IMPORTANT SAFETY RECALL

NHTSA Safety Recall No. 13V-636

Customer Service Notice

Feeder Tube Bracket Improvement

Figure 1 — Feeder Tube Bracket Location

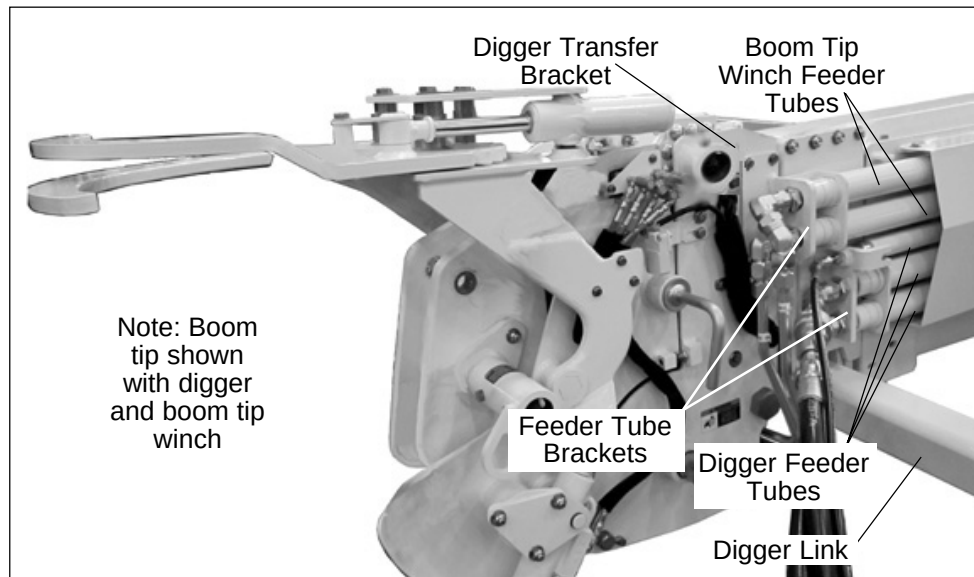
Altec has discovered that the bolt-on feeder tube bracket may separate from the digger transfer mechanism under certain conditions. If the bracket attachment fails, the feeder tubes may separate from the boom. **Death or serious injury can result from being hit by a falling feeder tube.**

1. Position the unit on a level surface, apply the parking brake and chock the wheels. Engage the unit's hydraulic system. Properly set the outriggers.
2. Raise the boom and rotate the unit so that the boom can be lowered close to the ground so the boom tip can be easily reached.
3. Locate the feeder tube bracket attached to the digger transfer bracket (refer to Figure 1). There is also a bracket for the boom tip winch feeder tubes, if the unit is so equipped.

If the unit is equipped with both a digger and a boom tip winch, both feeder tube brackets must be replaced.

Altec requires an immediate inspection of the bracket and the condition of the bracket fasteners on all affected units. The inspection should be done at least monthly until a Feeder Tube Bracket Improvement Kit is installed on the unit. Select the correct kit from the chart at the end of the inspection procedure. The inspection procedure is explained on Page 2. The kit must be installed at the next service interval but no later than six months from the receipt of this CSN. Order the kit by calling 1-877-GO ALTEC (1-877-462-5832).

Figure 2 — Measuring The Cap Screw Distance

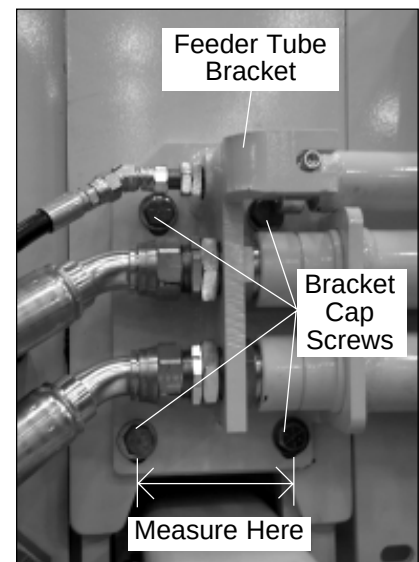
4. The feeder tube bracket is mounted to the digger transfer bracket using four cap screws. Check the cap screws to be sure they are not damaged, broken, or missing. Make sure each cap screw is torqued to 19 ft-lb.
5. For D2000A or B, D3000A or B, and D4000A or B units: if the digger is mounted on the right side of the boom (determined by looking from the boom tip toward the turntable), measure the distance between the center of the two bottom cap screw heads (refer to Figure 2). This measurement is required to order the correct replacement kit. No measurement is required for the DT80, units with the digger mounted on the left side of the boom, or units with a boom tip winch.

- 6.If the cap screws and bracket are in good condition, the unit can continue to be used until the feeder tube bracket is replaced at the next scheduled service interval. If the cap screws are damaged or missing or if the bracket is damaged, remove the unit from service until the Feeder Tube Bracket Improvement Kit can be installed.
- 7.After inspecting the bracket and the cap screws, stow the unit. Retract the outriggers, disengage the unit's hydraulic system. Return the unit to service if the inspection did not show damage.

Use the chart below to order the proper kit for the unit affected. The kit includes a new bracket and additional or larger fasteners for the bracket attachment and instructions.
